Technical Service Bulletin

Affected Applications:

Item 6 is Jeep shim 4797072

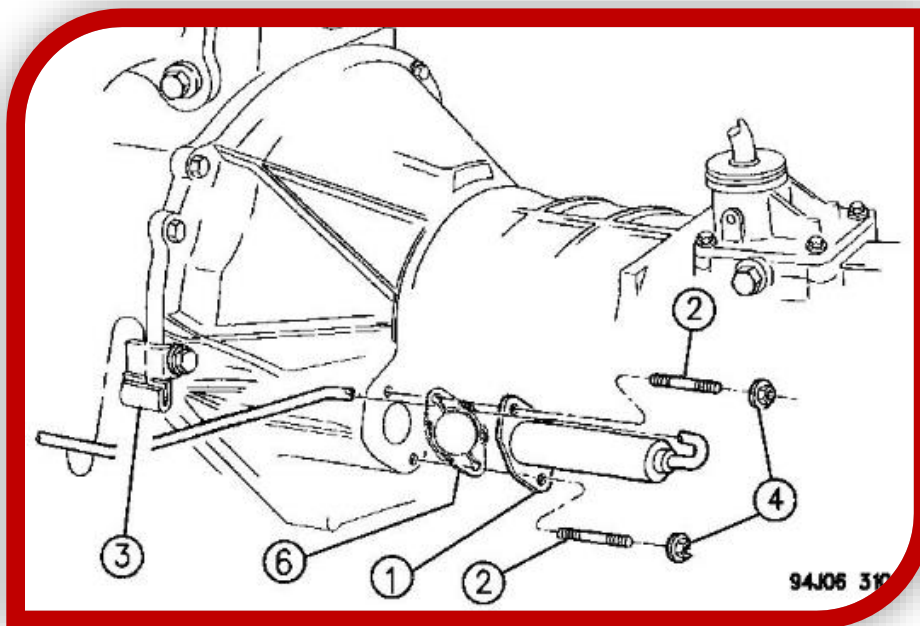
Premature clutch wear may be caused by insufficient clearance between the bell housing and slave cylinder. The slave mounting surface is located too far forward, restricting movement. This prevents proper fork movement, causing partial release and slippage.

Install a shim, Jeep part #4797072, between the slave cylinder and bell housing to avoid premature wear.
